TO: All Interested Bidders
SUBJECT: Invitation for Bids #16-1034CD
Wares Creek Pedestrian Bridge Replacement

ADDENDUM #1

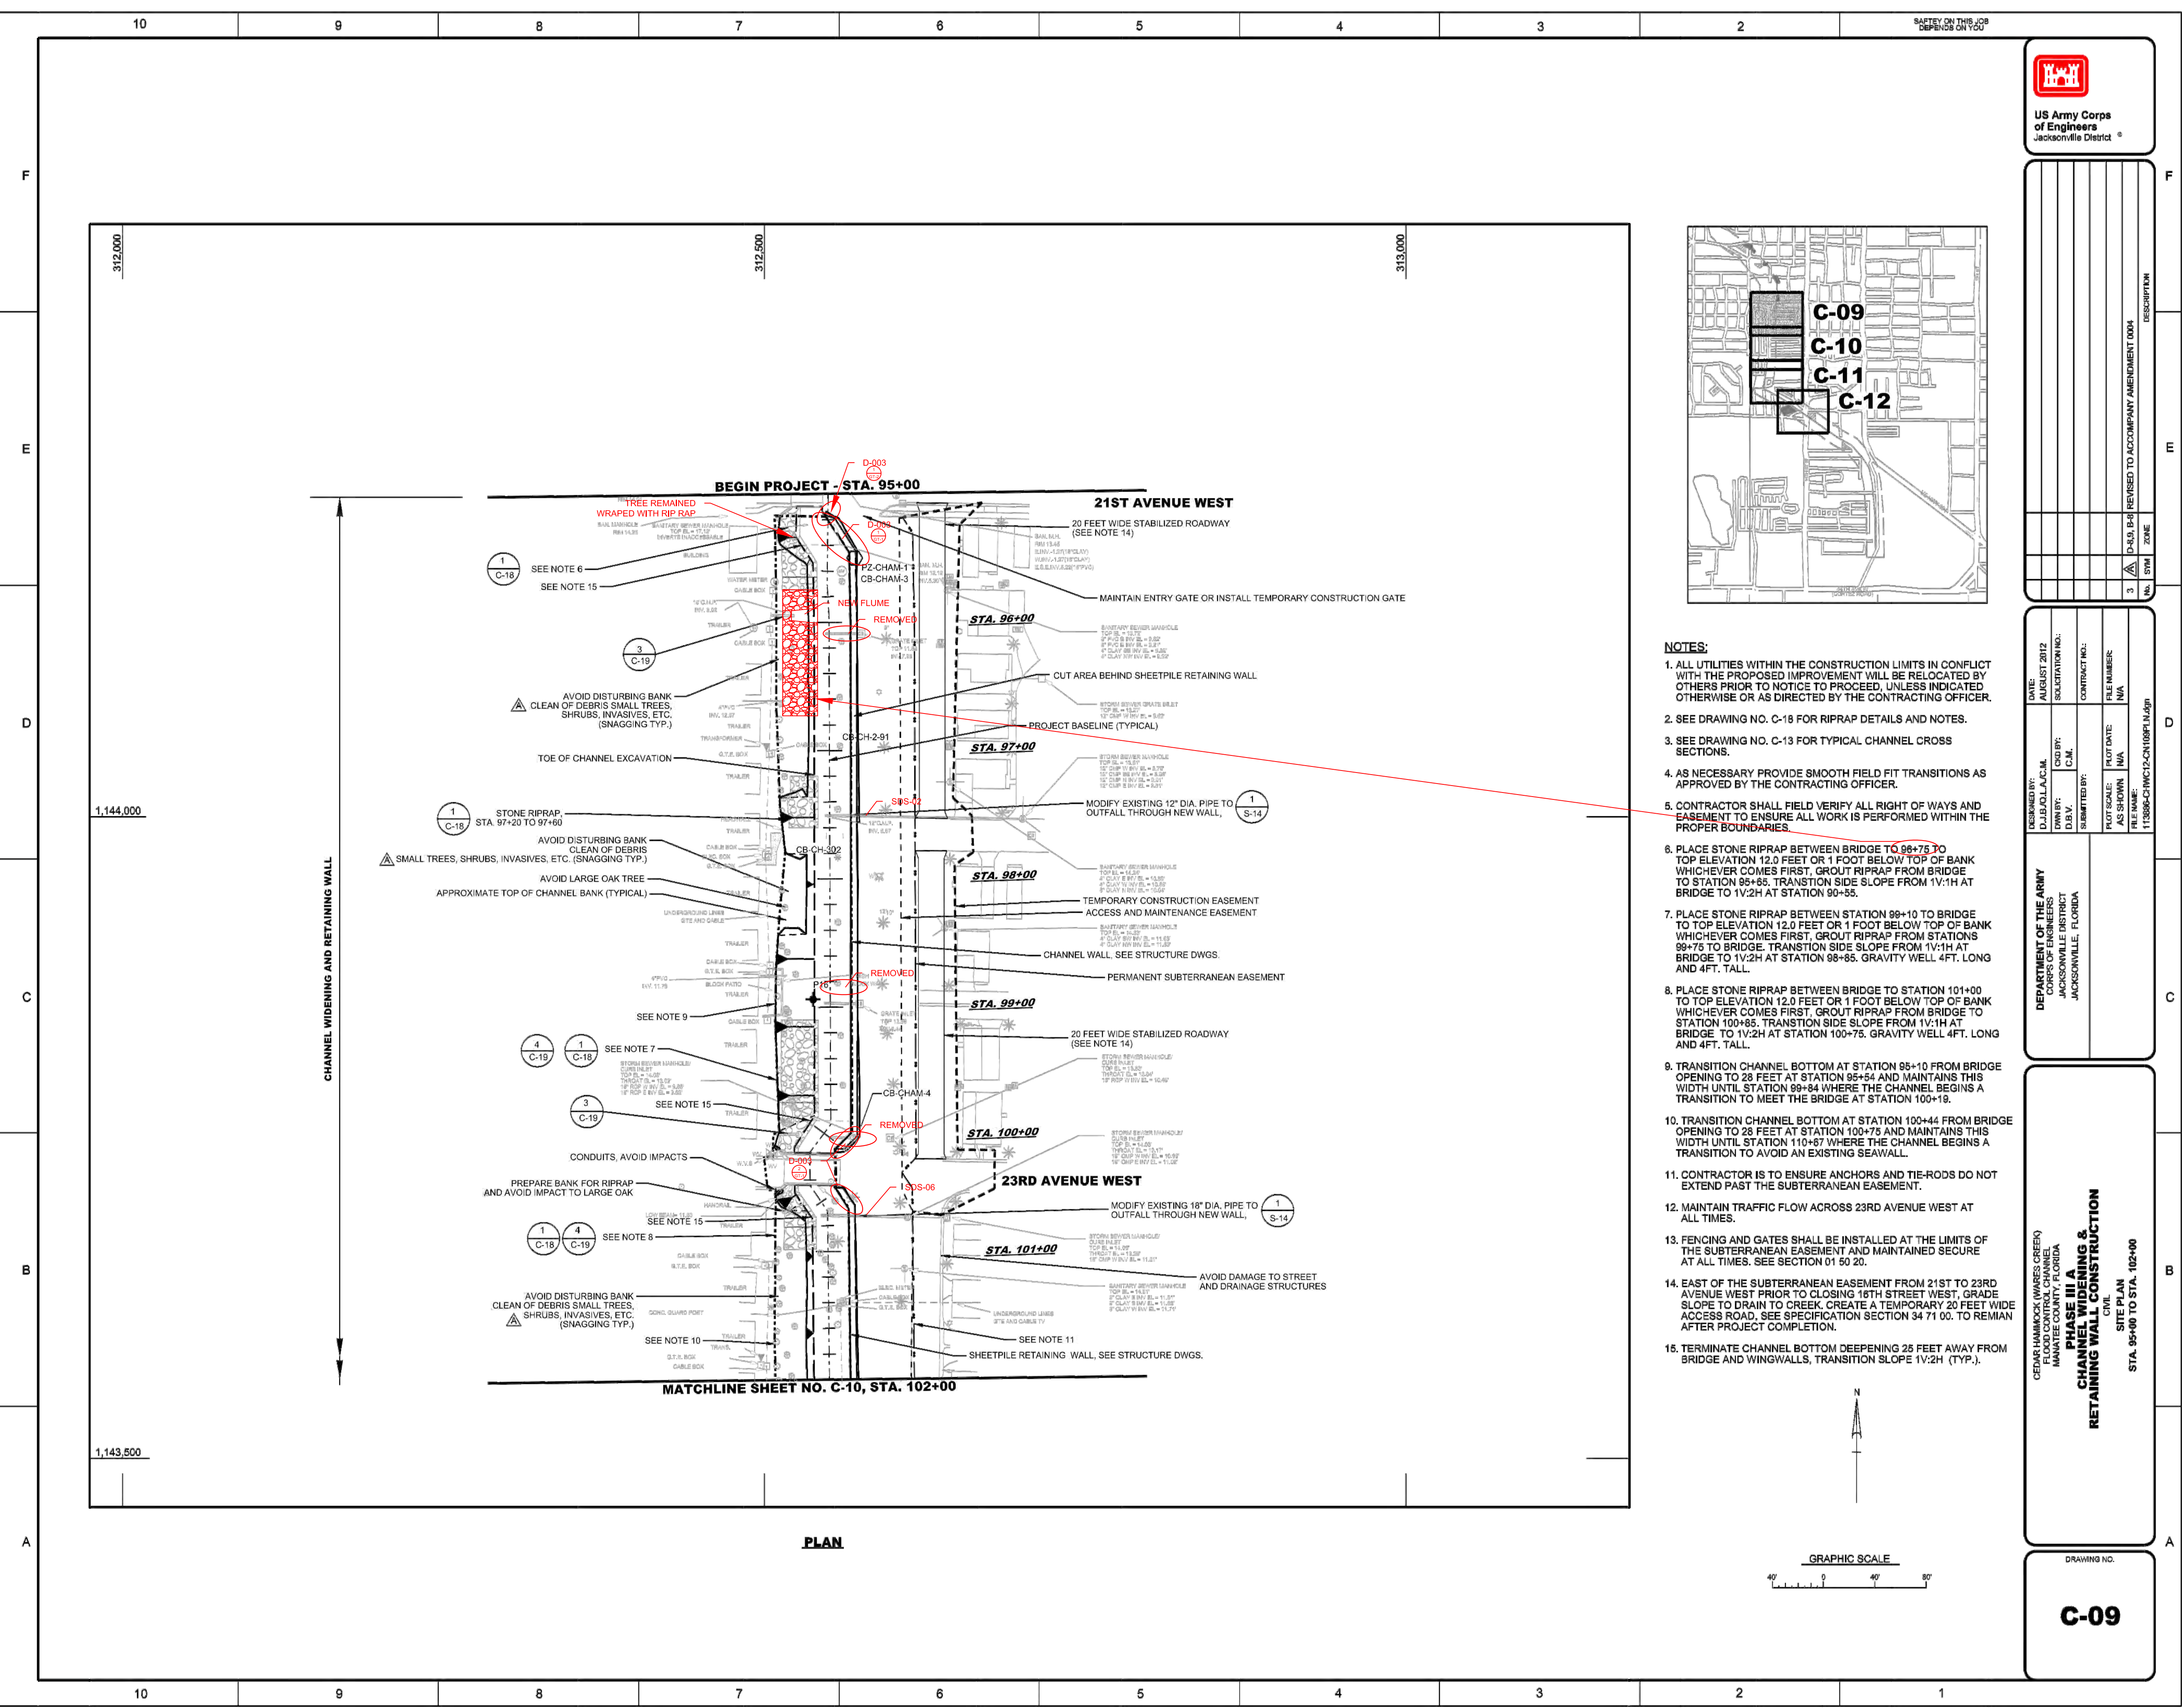
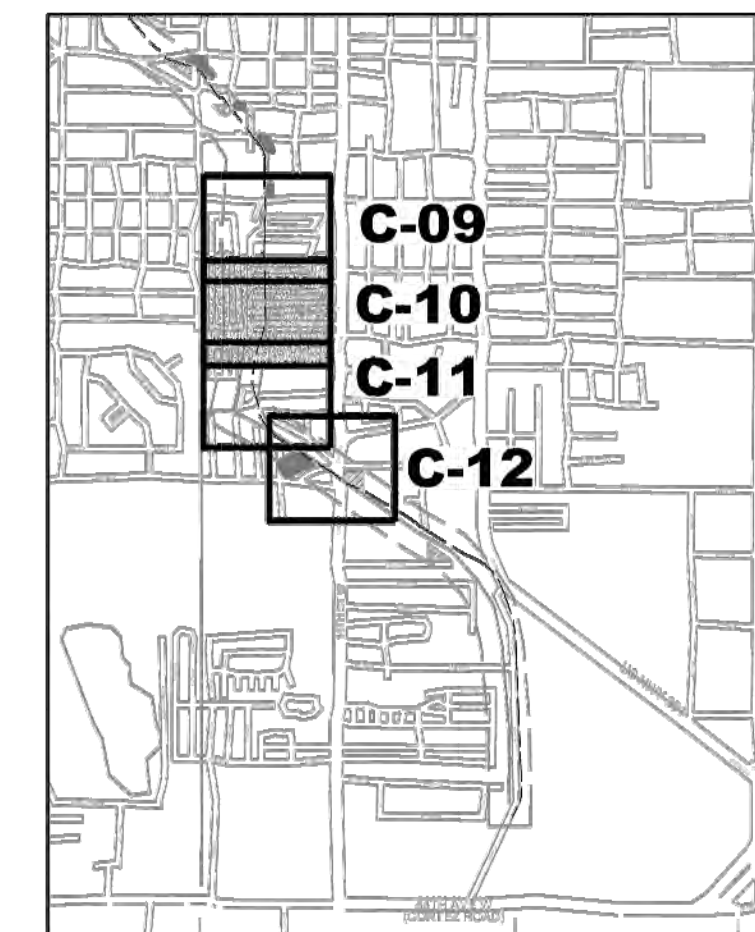
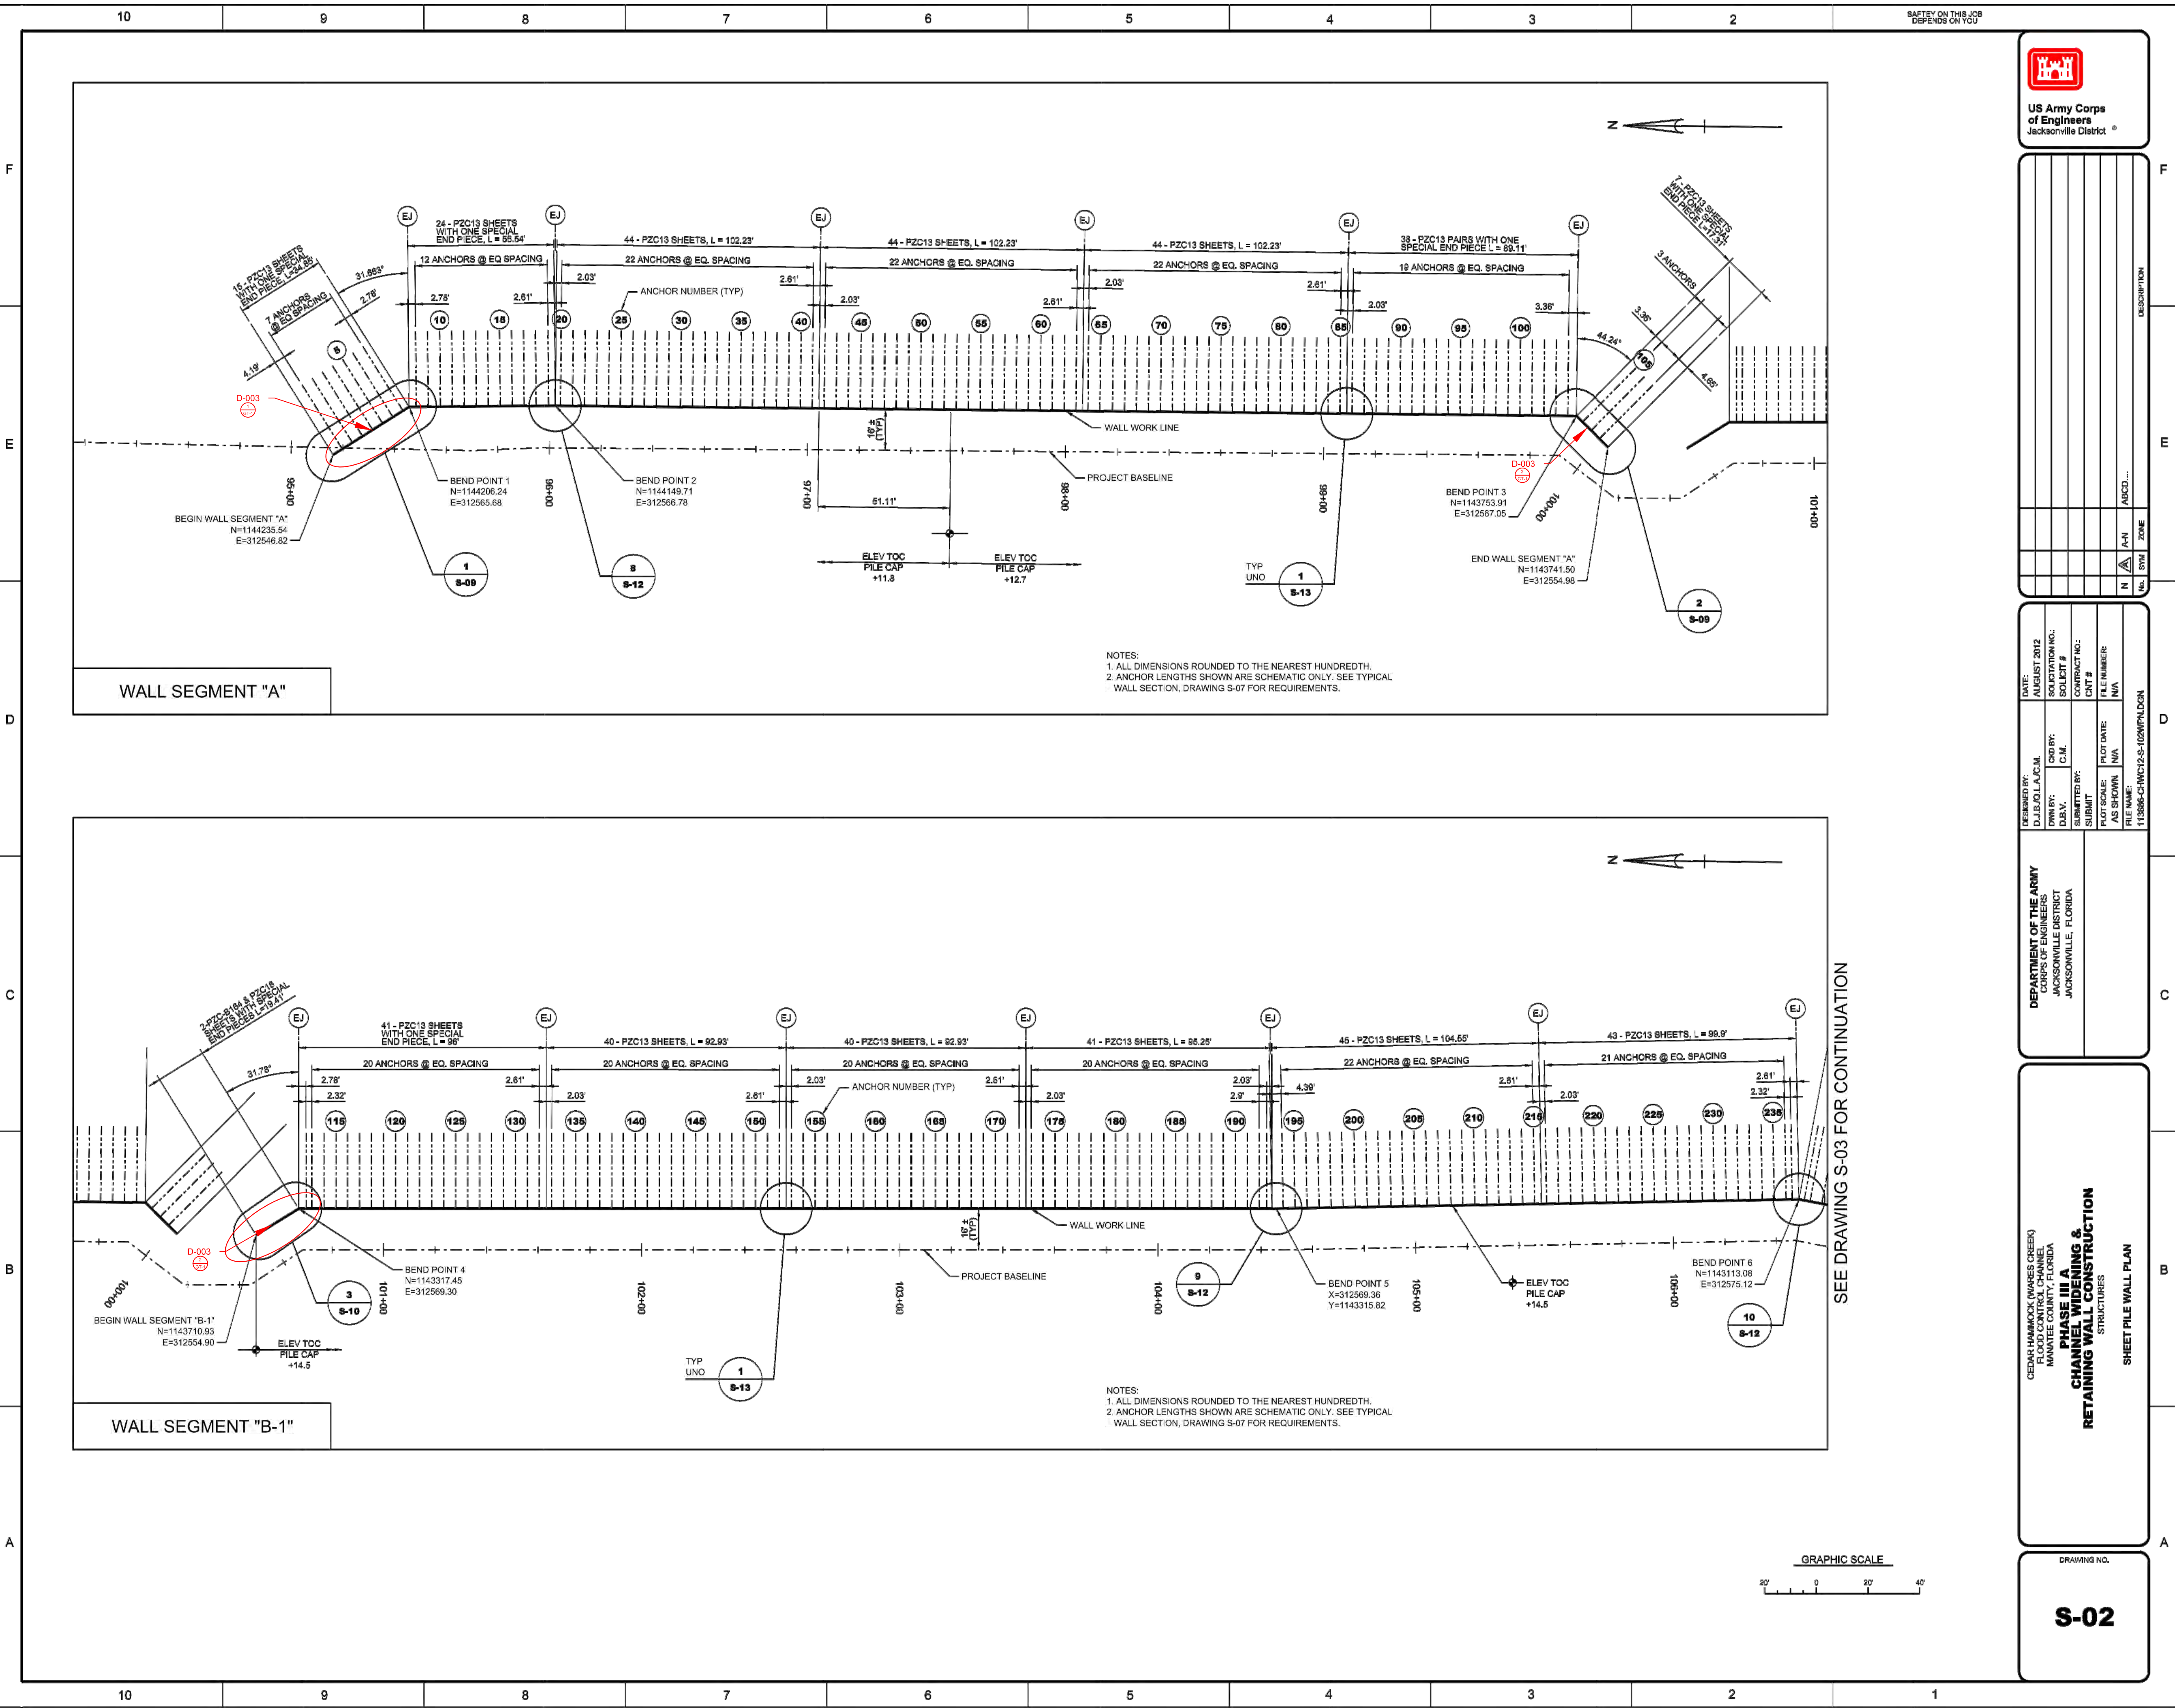
Question 9: Is there any as-built drawings for tie-backs?

Response 9: Please see attached as-built drawings for tie-back locations provided by USACE.
